Based on Solder:Time, ClockIt, and Serial 7-Segment

TITLE: \${PROJECTNAME}		SFE	SFE
Document Number:		REV: V15	
Date: \${CURRENT_DATE}		Sheet: \${#}/\${##}	
Size: User		Date:	
KiCad E.D.A. kicad-cli 7.0.6-7.0.6-ubuntu22.04.1		Rev: Id: 1/1

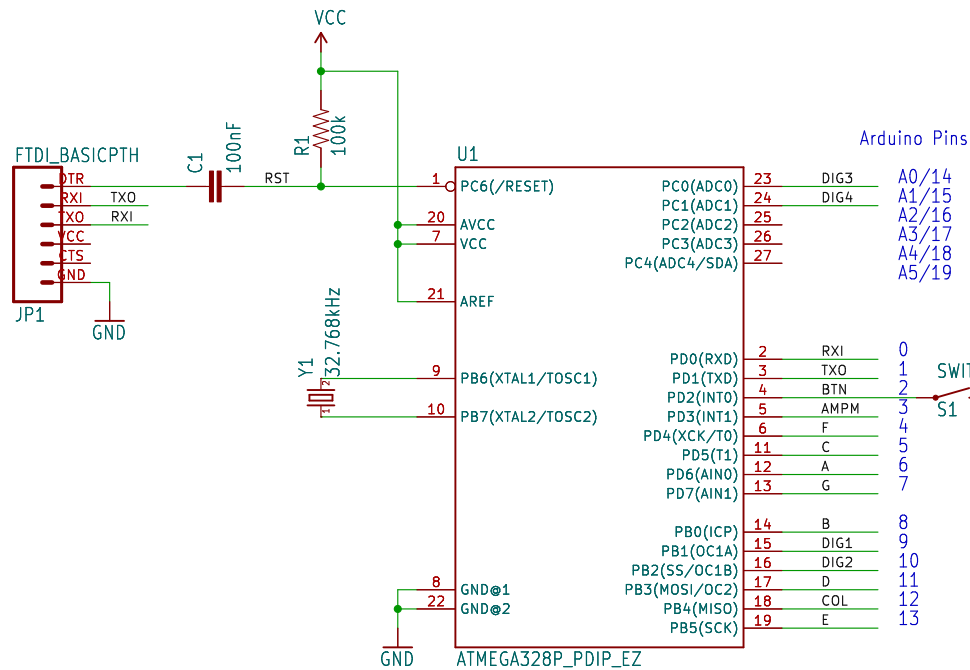
Changes to v11:
Swap TX/RX
Silk Update
Tented the one via
Increased R1 to 100k

Changes to v12 (1/6/12 MH/PL):
updated package on 7-seg display
updated package on ATMEGA328

Changes to v13 (4/26/12 PL):
updated package on Coin Cell
Added polygon pours around
pads on coin cell connector
to prevent pulling pads during assembly
Moved SFE logo to avoid clipping

Changes to v14 (2/13/13 MAH):
Change coin cell to PTH

Changes to v15 (24 Apr 13 MAH):
Scoot battery holder down a bit
